Report No. FAA-RD-71-104

INTERMEDIATE ACTIVITY LEVEL TOWER CAB EVALUATION-PHASE II

DECEMBER 1971

FINAL REPORT

FIGURE 2 - NAFEC TOWER CAB LABORATORY

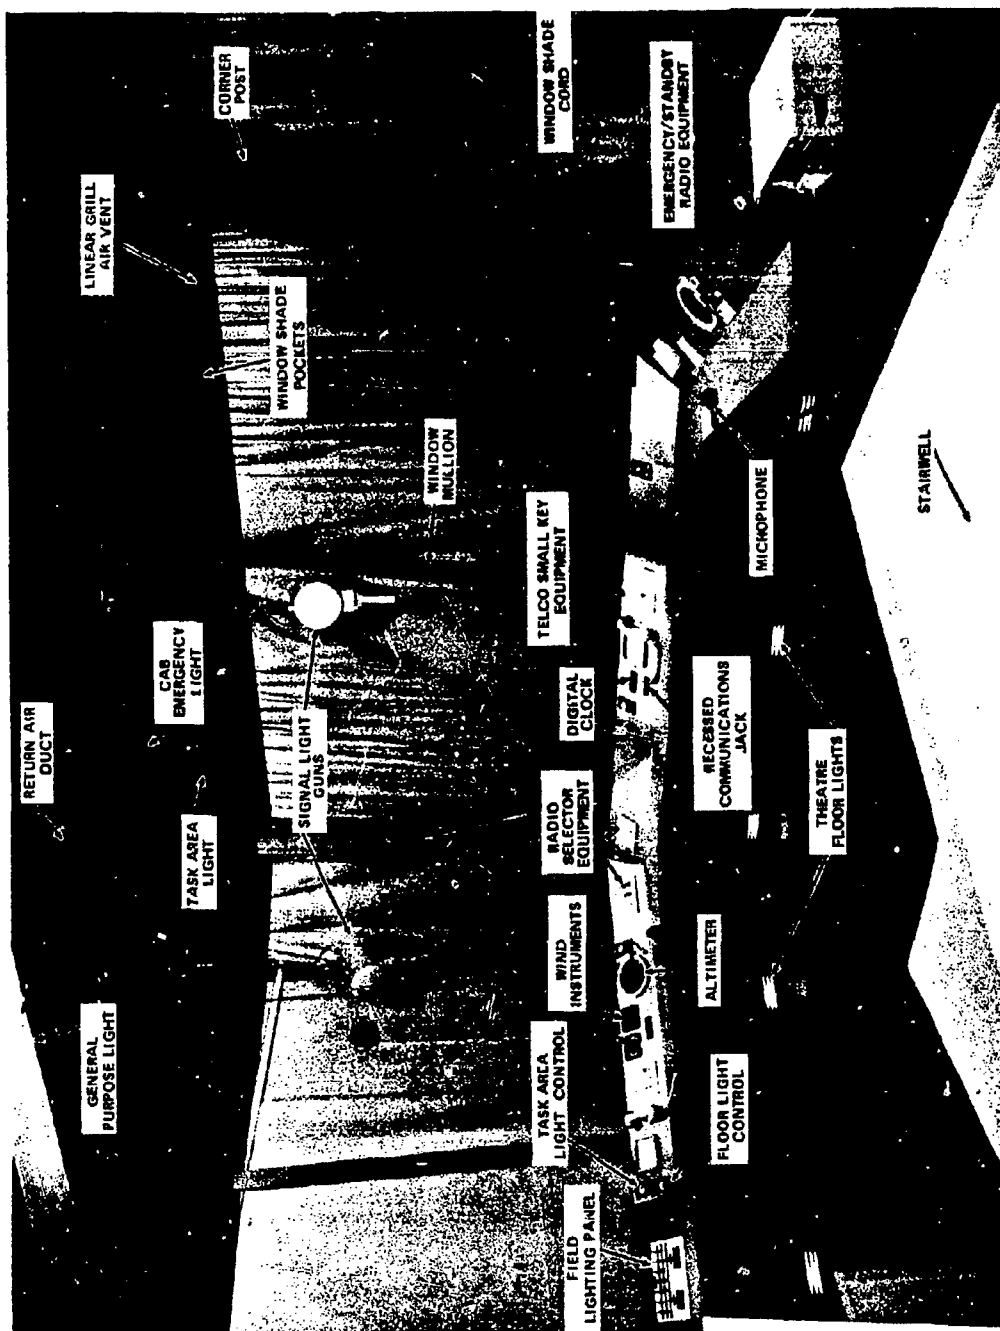
The Tower Cab: The tower cab is six-sided, has a 10-foot clear ceiling space, vertical walls to the window sill, and the windows slope outward at 15°. As shown in Figure 2, the tower cab corner posts have a maximum cross-sectional dimension, as viewed from any angle, of 14 inches; while a similar measurement for the window mullions is 4 1/2 inches. It was noted that the tower cab size and shape satisfied operational requirements; however, concern was expressed over the comparatively large size of the corner posts and window mullions.

Light Systems: The position (console) lights consisted of six units, Lightolier Model 7051, that were recessed mounted in the ceiling (Figure 2) over the operators' console. Each lamp had its own "push-to-click" off/on switch and dimmer control located on the console equipment turret. The adequacy of the position lights and location of the controls were judged excellent. It was suggested that a "turn-to-click" off/on switch and dimmer control would preclude activating the lamp at a high-intensity setting, thereby extending the life expectancy of the bulb.

Consoles: The operators' console was developed in Phase I. The basic components consist of a small base unit, a 12-inch shelf and equipment turret. The console shown in Figure 2 has a writing surface 30 inches above the floor. This is considered a normal "sit" console. There is an 8-inch spacer component that may be provided as an option. The purpose of the spacer is to raise the shelf and equipment 8-inches higher for a "sit/stand" operation. FAA regions may order any combination of sit or sit/stand arrangement that suits individual regional requirements. The console is finished with a gingersnap colored, glare-free matte finished formica which was rated excellent.

FIGURE 4 - NAFEC TOWER CAB LABORATORY SHOWING JUNCTION
ROOM LEVEL AND TOWER CAB BASE

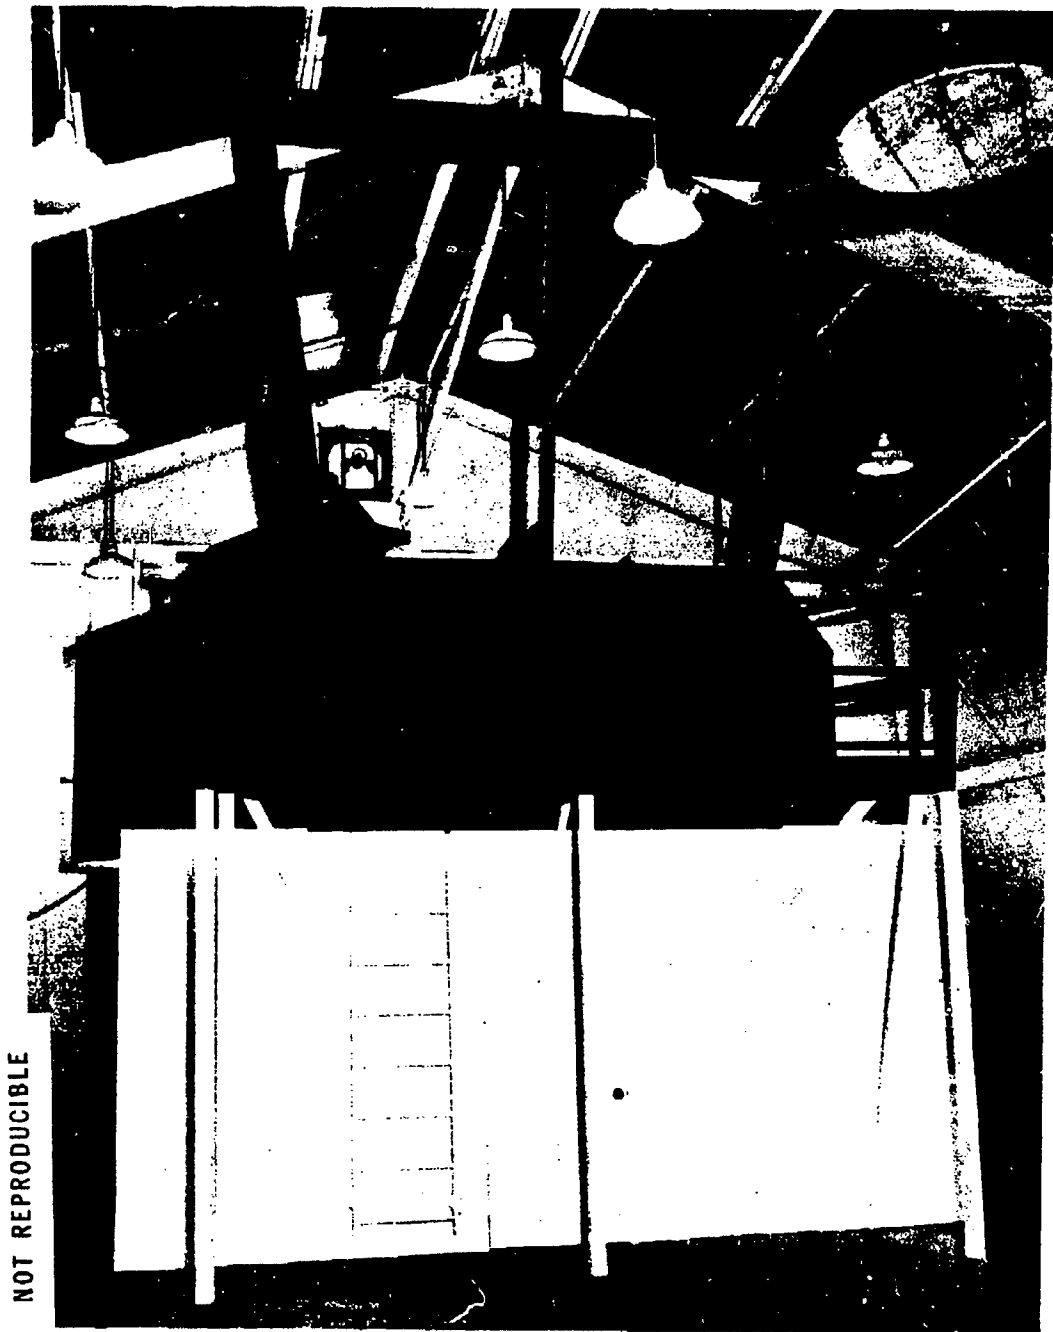
The Junction Room Level: The purpose of the junction room level (Figure 4), in addition to adding height to the tower structure, is to provide an area for a stairway to other levels, elevator shaft or storage room, water pipe chase, lavatory, ac and dc panel boards, equipment racks and clothes rack. The junction room level was rated as follows; stairs from the tower cab to the catwalk landing (Figure 6) and from this landing down to the junction room (Figure 7), very good. The stairs to the lower levels, although not mocked-up, met the standard codes for handrail safety. However, it was suggested that a wire mesh installation be included with the handrail as an added protection feature for facility personnel and visitors.
